# UNITED STATES PATENT AND TRADEMARK OFFICE

| APPLICATION NO.  | FILING DATE | FIRST NAMED INVENTOR | ATTORNEY DOCKET NO. | CONFIRMATION NO. |
|--|-------------|----------------------|---------------------|------------------|
| 10/696,661   | 10/28/2003  | Brent Neudorf        | 571                 | 6848             |

## Office Action Summary

## DETAILED ACTION

FIG 1: Chubb et al (original)

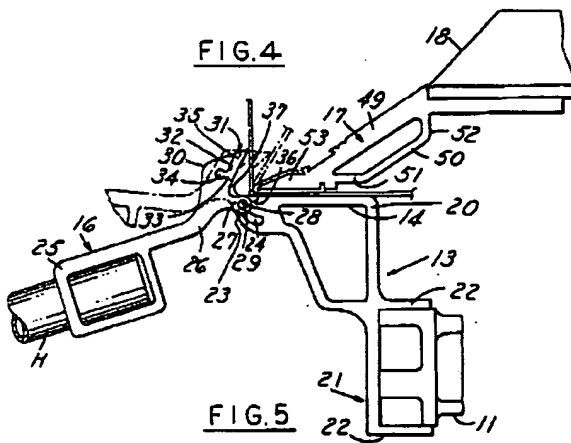
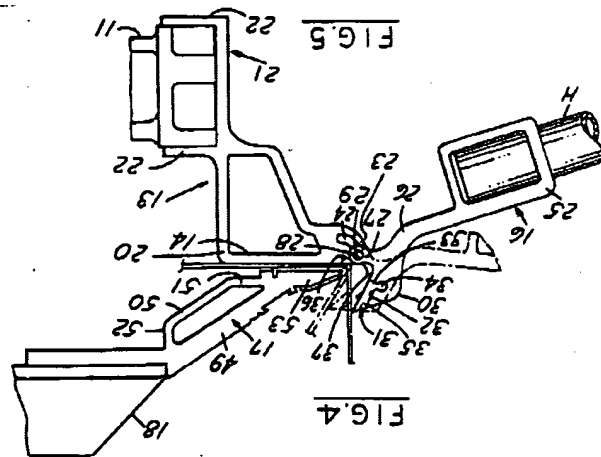
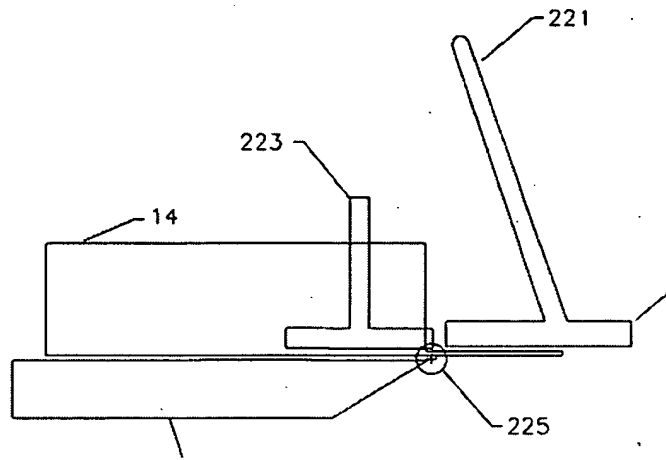
1. Determining the scope and contents of the prior art.
  2. Ascertaining the differences between the prior art and the claims at issue.
  3. Resolving the level of ordinary skill in the pertinent art.
  4. Considering objective evidence present in the application indicating obviousness or nonobviousness.
1. Claim 17 is rejected under 35 U.S.C. 103(a) as being unpatentable over Chubb et al (U.S. Patent # 6,085,569). Chubb et al discloses a heavy duty sheet bending brake having a hold down (fixed member, 13) with a clamping surface (14), a panel support (anvil member, 17) and a brake

plate (bending member, 16) with a brake handle (handle, H). Chubb et al discloses the claimed invention except for wherein a tool adapted to hem an exposed tongue has an angled panel support such that a roofing panel is secured on the panel support by the hold down and pressure is applied to the tongue by the brake handle so that the tongue is bent around a brake pivot on an end of the panel support. It would have been obvious to one having ordinary skill in the art at the time the invention was made to rotate the support panel and the hold down by 180 degrees to bend the tongue downward instead of upward as disclosed by Chubb et al, since it has been held that a mere reversal of the essential working parts of a device involves only routine skill in the art. (See FIG 1-3)
